# **PARACHUTES AUSTRALIA**

## **SERVICE BULLETIN No PA SB9101**

**SUBJECT:** DIAPER FITTED TO PA AEROLITE AND HOBBIT RESERVE CANOPIES

B029 (affected)

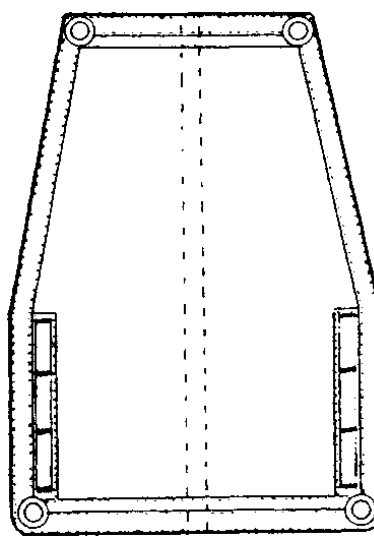
**BACKGROUND:** There have been reports of the flat grommets and washers on the B029 diaper pulling away from the material during packing or as a result of a deployment.

**MANUFACTURER ADVISORY:** All Hobbit and Aerolite reserve canopies fitted with a B029 diaper are to be inspected at the next scheduled repack for material separation from the grommets.

If separation is evident, the canopy may be returned to PA for repair. Alternatively, the grommets may be reset or replaced by a Rigger.
